SIL 10-WT-23 April 02, 2025 Page 1 of 3

SUBJECT: M-Point Flexplate Bolt — PACCAR MX11 and MX13

MODELS AFFECTED: 4000 Series[™] Transmissions

Figure 1. Flexplate Adapter Bolt Comparison

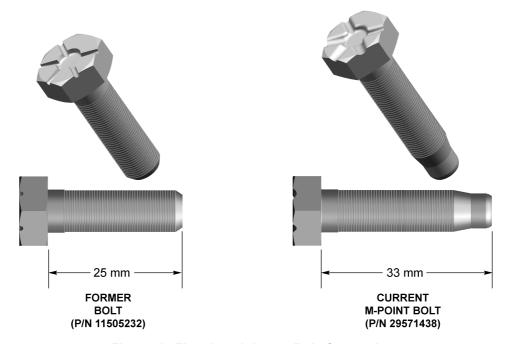
The current bolt is slightly longer in length from the flange to the bolt end. The current bolt is visibly distinguishable by its unthreaded end – refer to Figure 1. The additional length necessitated a change to the depth of the tapped hole in the corresponding flexplate adapter for clearance – refer to Figure 2. Due to a potential interference between the current bolt and the former flexplate adapter (refer to Table 1), and because the former bolt services both flexplate adapters, the current bolt will not be available for service. The former bolt will continue to be available as a service part servicing the former and current configurations. Installation method and installation torque are unchanged. Do not mix current and former bolt part numbers in the same assembly.
